DESIGN DS	DRAWN BY DS	DART AEROSPACE LTD VICTORIA INTERNATIONAL AIRPORT, CANADA	
CHECKED <i>[Signature]</i>	APPROVED <i>[Signature]</i>	DRAWING NO. DEO 9095	REV. A SHEET 1 OF 1
DATE 97.10.29		TITLE 206 SADDLE GROOVE CHANGE	SCALE NTS

DART ENGINEERING ORDER

TO AMEND DWG :

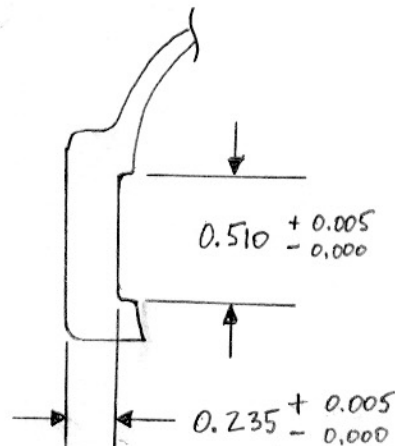
THE DIMENSION OF THE GROOVE THAT INTERLOCKS THE SADDLES
ONTO THE SKIDTUBES SHOULD READ AS FOLLOWS:
